Prairie Island Nuclear Generating Plant
License Amendment Request Dated January 13, 1986

Evaluation of Proposed Changes to the
Technical Specifications Appendix A of
Operating License DPR-42 and DPR-60

Proposed Changes Marked Up
on Existing Technical Specification Pages

FIGURE ~~TS.3.10-8~~
REV ~~34~~ 4/20/79

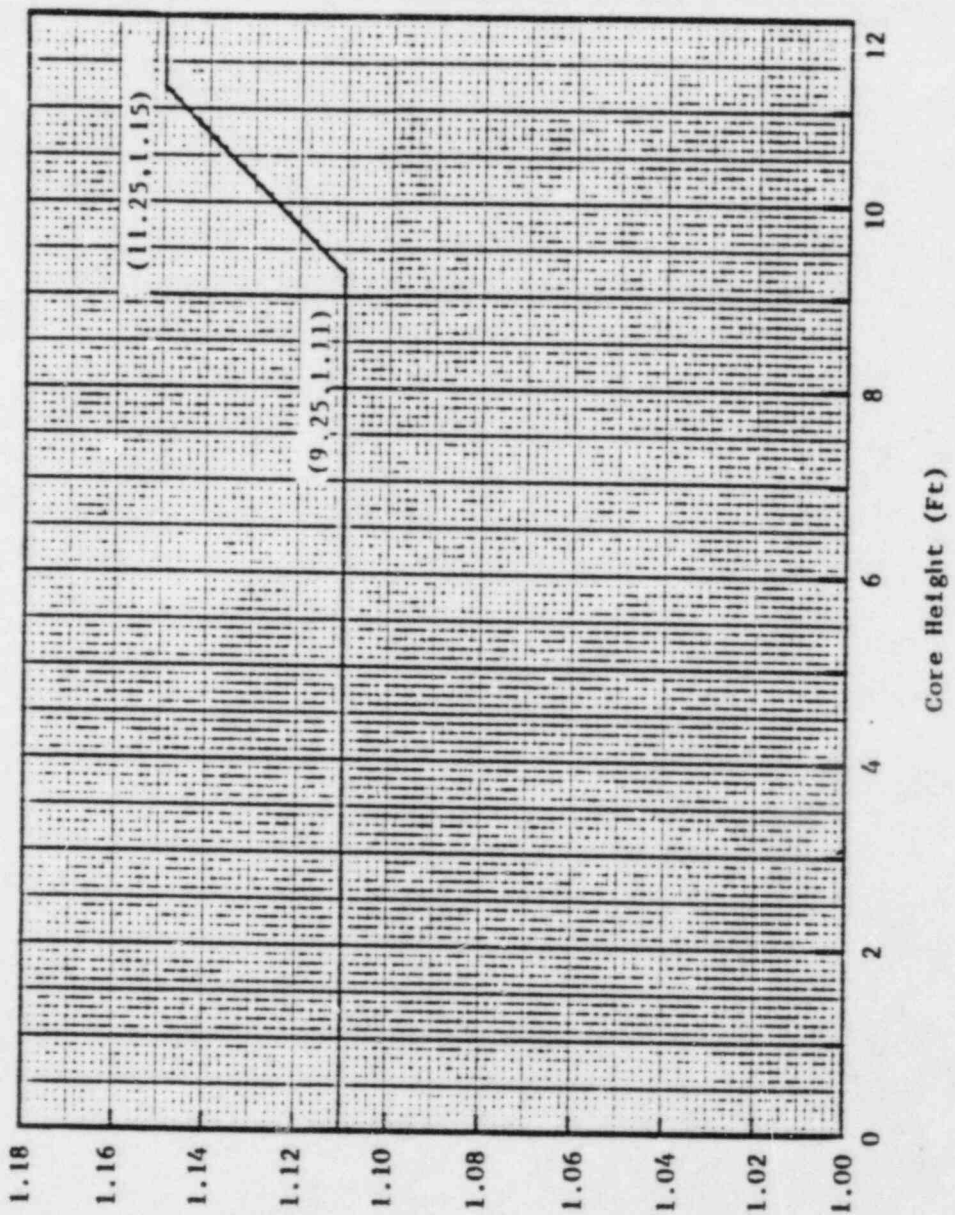
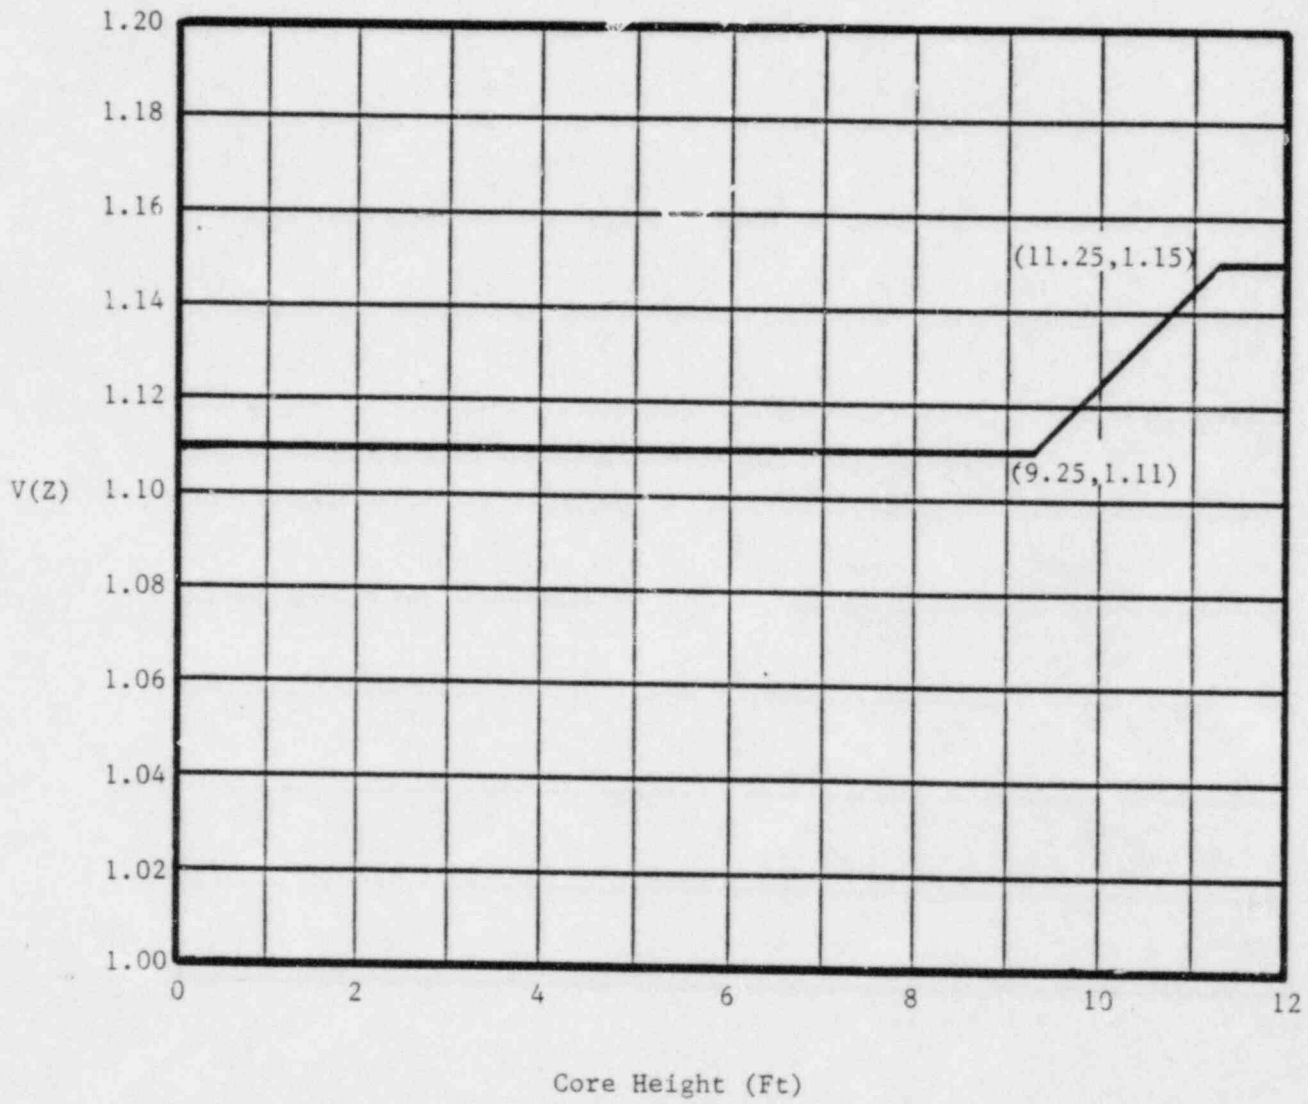
Delete Figure TS.3.10-7, renumber the next sequentially numbered curve and delete references to the curve.

TS.3.10-7

Redraw ↘
